SHOPS AT MERIDIAN RANCH CONVENIENCE STORE

Grading & Erosion Control Plans

PCD FILE NO. PRR2322

GEC PLAN
 TITLE SHEET

EROSION CONTROL DETAILS

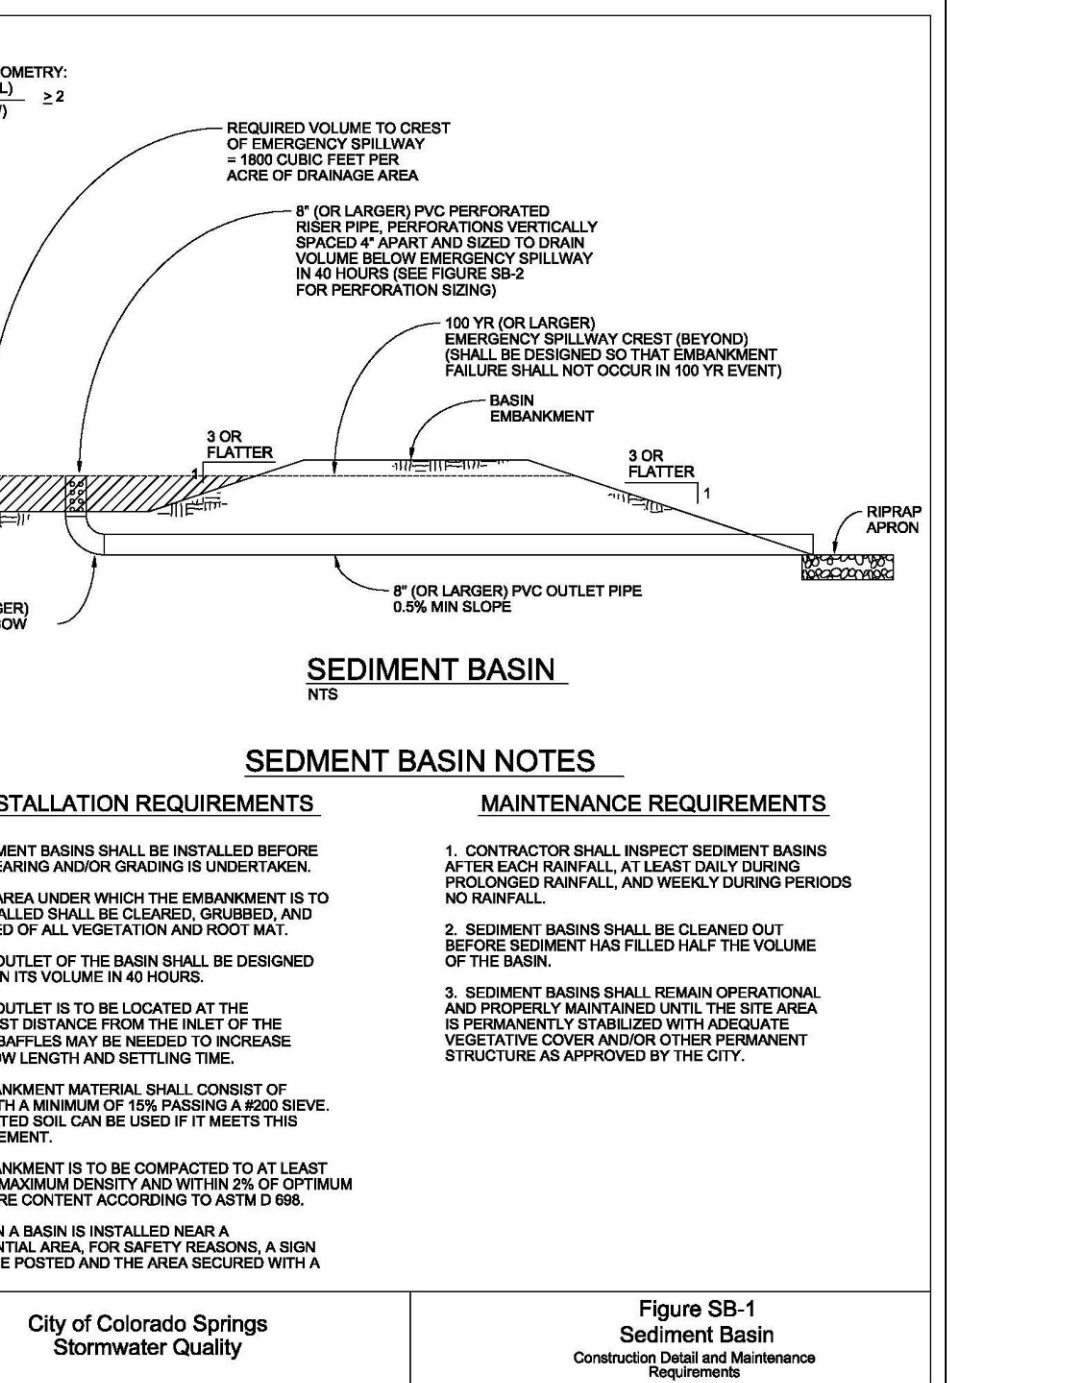
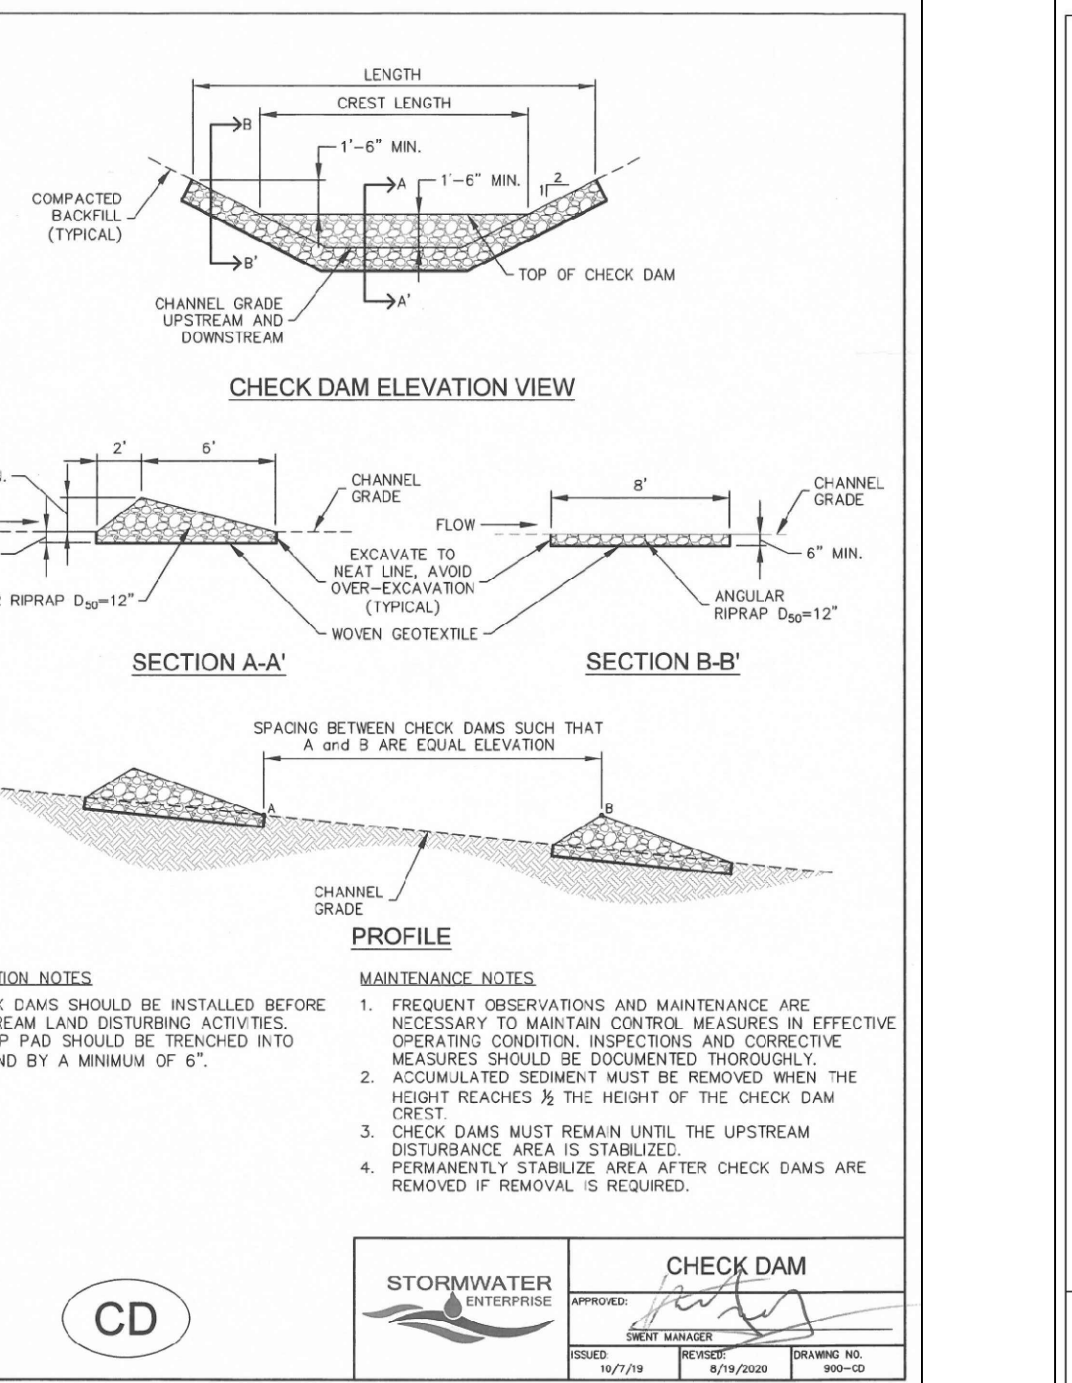
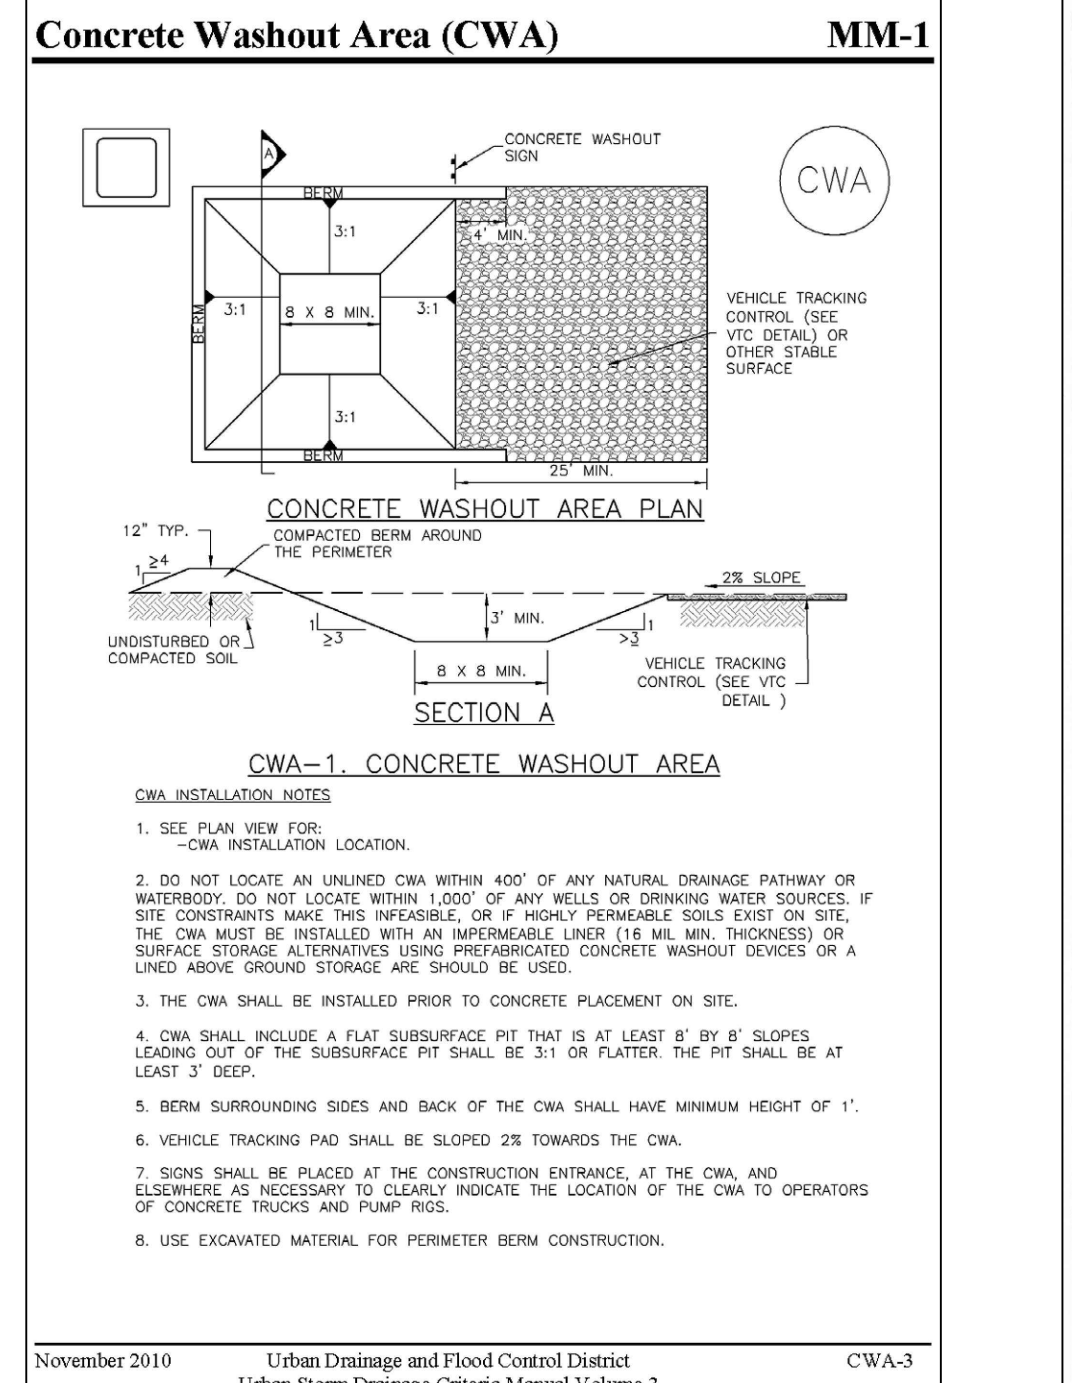
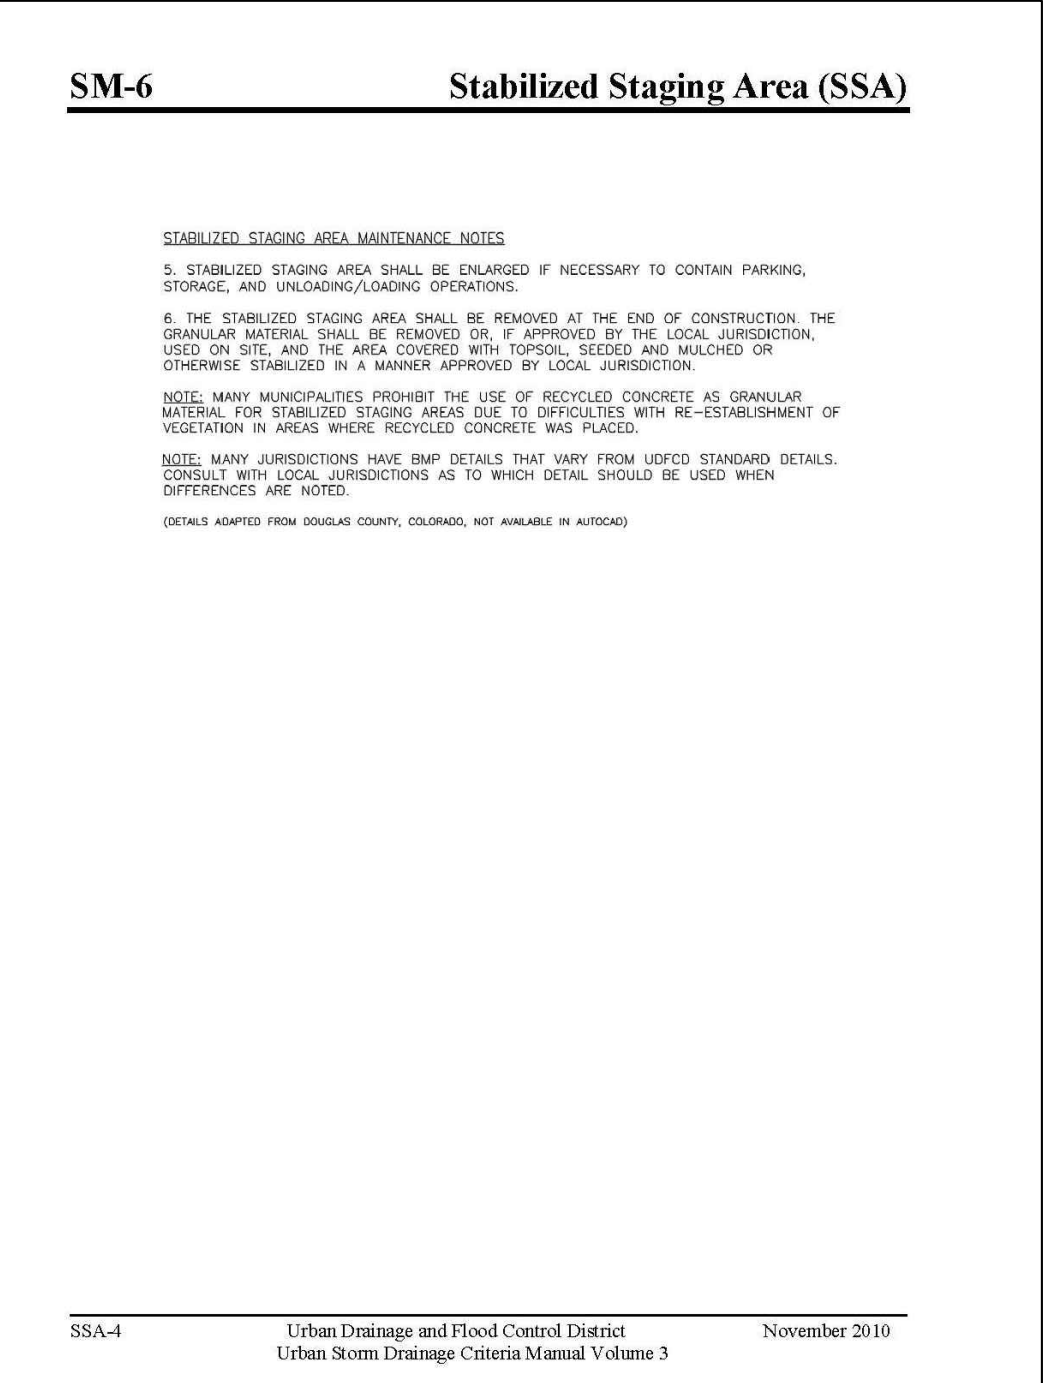
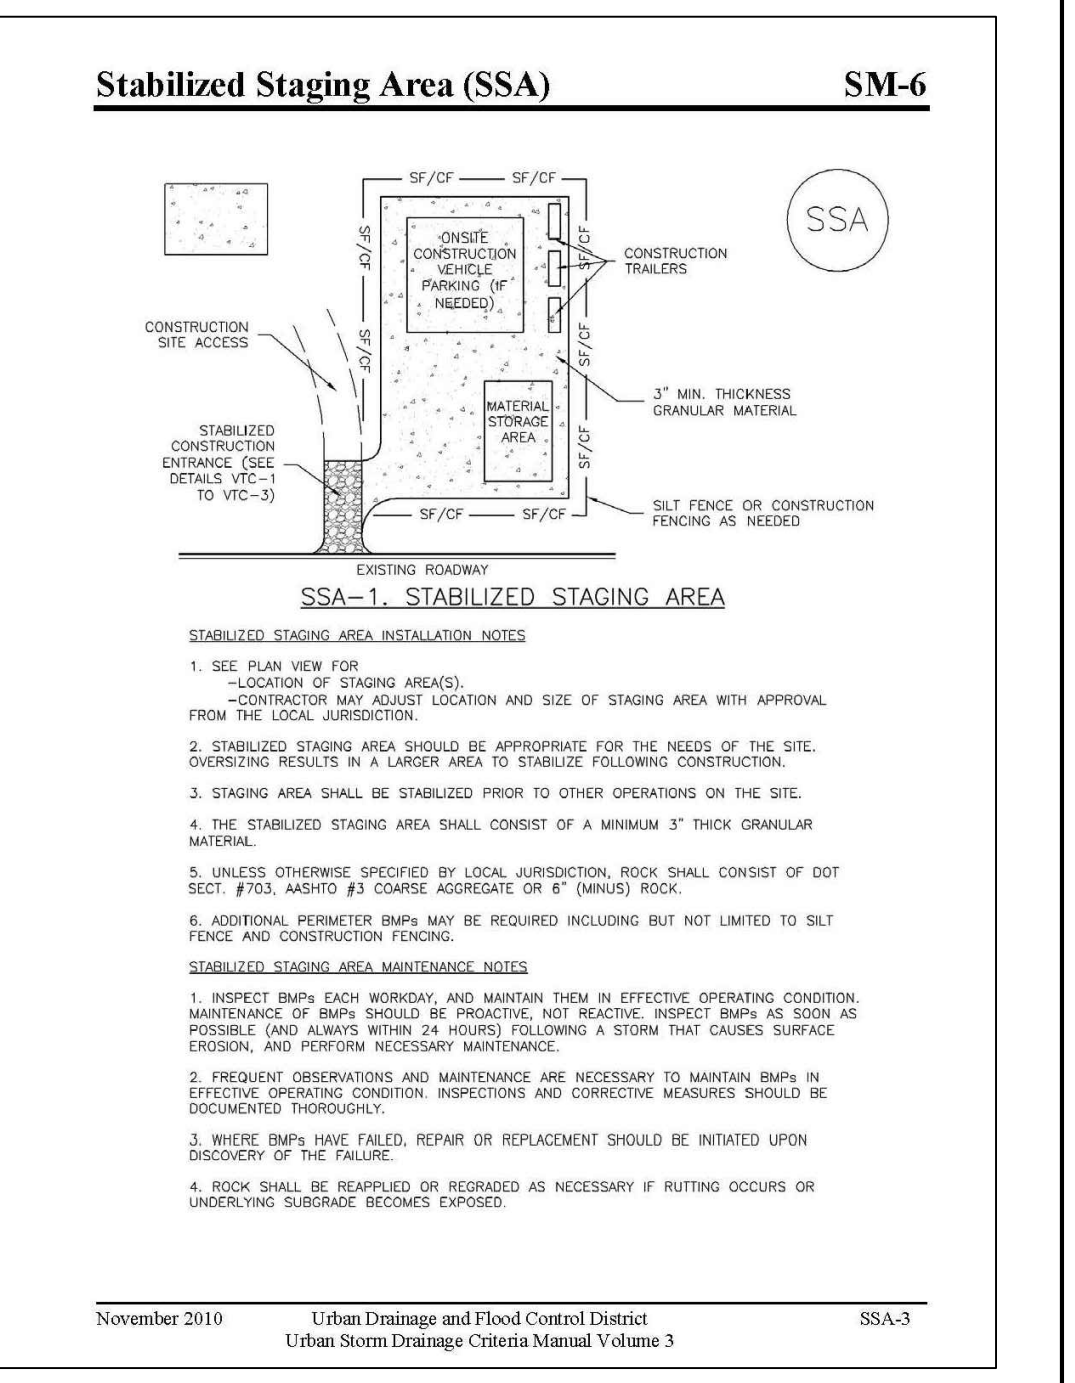
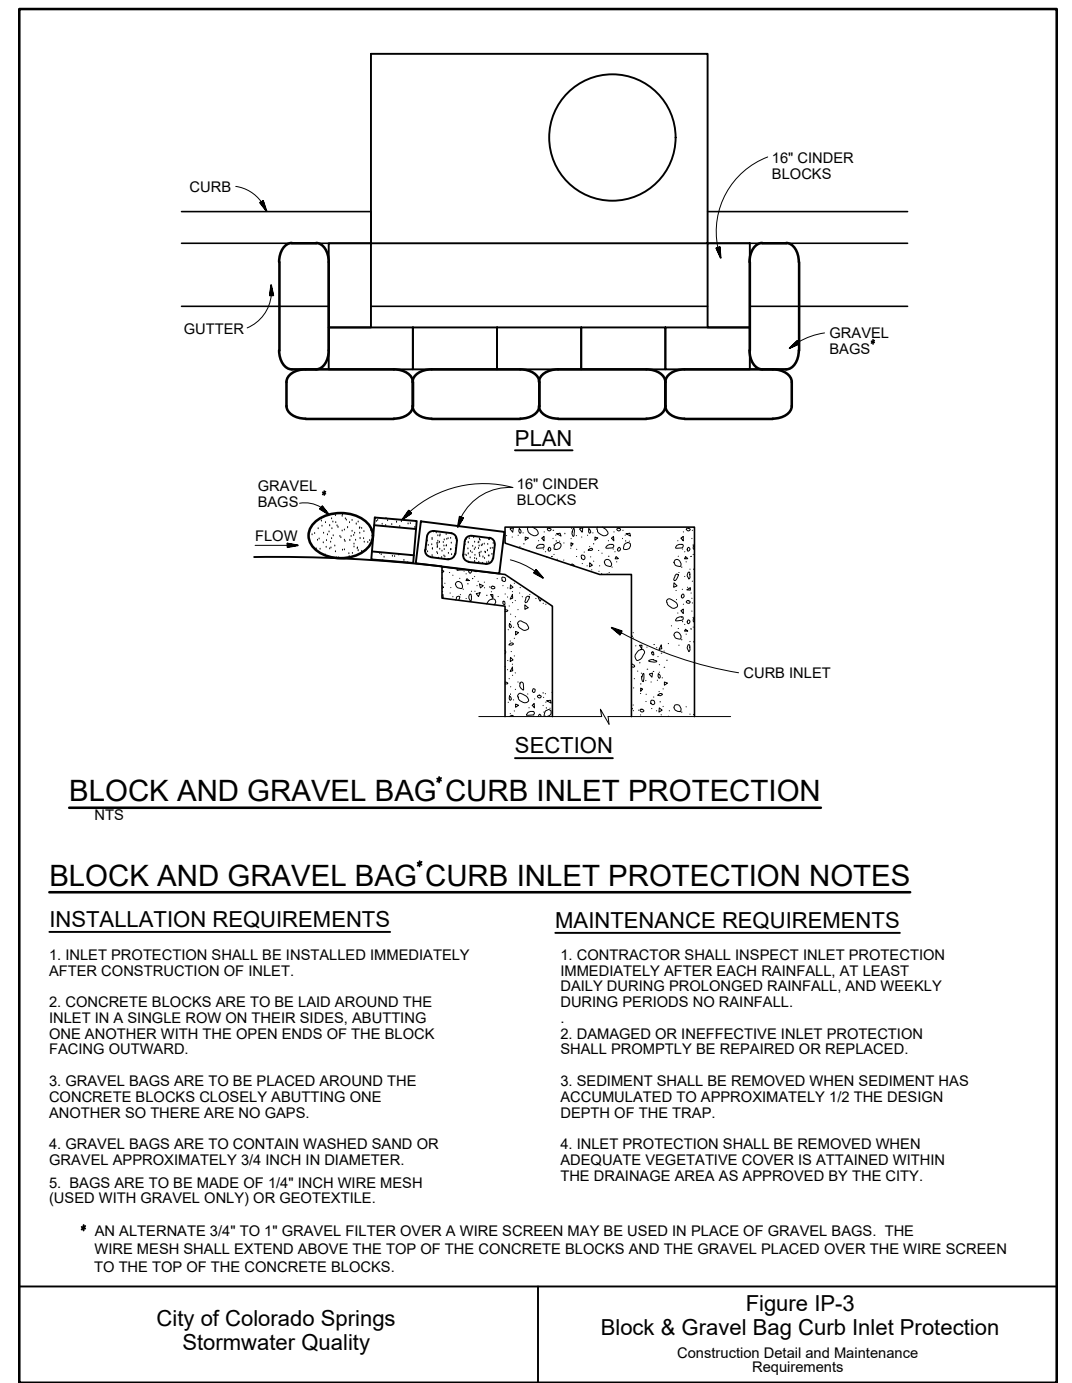
With my comments for Review 3, I requested contours be provided for the TSB. I'm not seeing any. Do you want to at least provide LxW dimensions to assist the contractor and your SW inspectors? Otherwise this volume and depth is all they will have to go-by. The MHD TSB details (SC-7) are better in that respect: they provide LxW dimensions.
